RE: Request for Comments

File No.: **D14-1666 & D12-449**

Applicant: Sean Mason Homes (Veteran's Lane) Inc.

Location 339 Veteran's Drive and 341 Veteran's Lane

PADMOUNT TRANSFORMER/SECTIONALIZER CLEARANCES

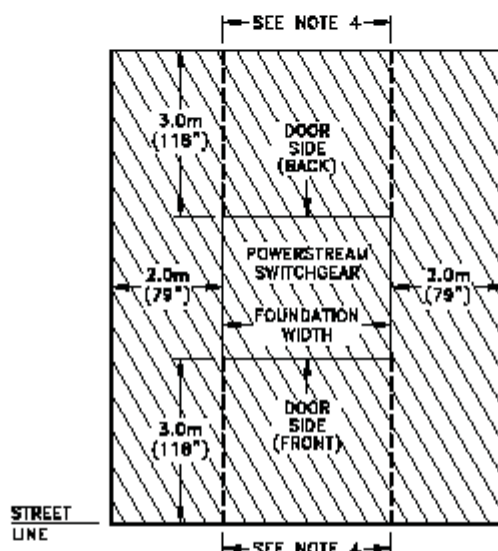
All communication, street light or other pedestal(s) or equipment(s) must not be installed near Alectra Utilities transformers and/or switchgears. Enclosed with this request for comments are Alectra Utilities clearance standards.

1. FINAL GRADE WITHIN THE RESTRICTED OPERATIONAL CLEARANCE ZONE (SHOWN AS "HATCHED ZONES" ABOVE) MUST NOT BE ALTERED.
2. HATCHED ZONES AROUND THE APPARATUS AND IN FRONT OF ACCESS DOORS/HOODS TO REMAIN CLEAR OF ALL SHRUBS AND TREES. WHEN THE APPARATUS IS POSITIONED WITHIN THE HATCHED ZONE, THE ZONE WITHIN OR ABOVE MUST REMAIN CLEAR OF, INCLUDING BUT NOT LIMITED TO, BUILDINGS, STRUCTURES, FENCES OR OBSTRUCTIONS INCLUDING ANY LANDSCAPING FEATURES.
3. PREFERRED SURFACE COATING WITHIN THE HATCHED ZONES IS LAWN (SEEDED OR SOD) AND WITH PRIOR WRITTEN CONSENT OF POWERSTREAM GRAVEL AND/OR PAVED WITH ASPHALT OR PAVERS OR A CONCRETE FINISH MAY BE PERMITTED.
4. ACCESS TO ALL EQUIPMENT DOORS/HOODS MUST REMAIN PERMANENTLY CLEAR OF ALL OBSTRUCTIONS.
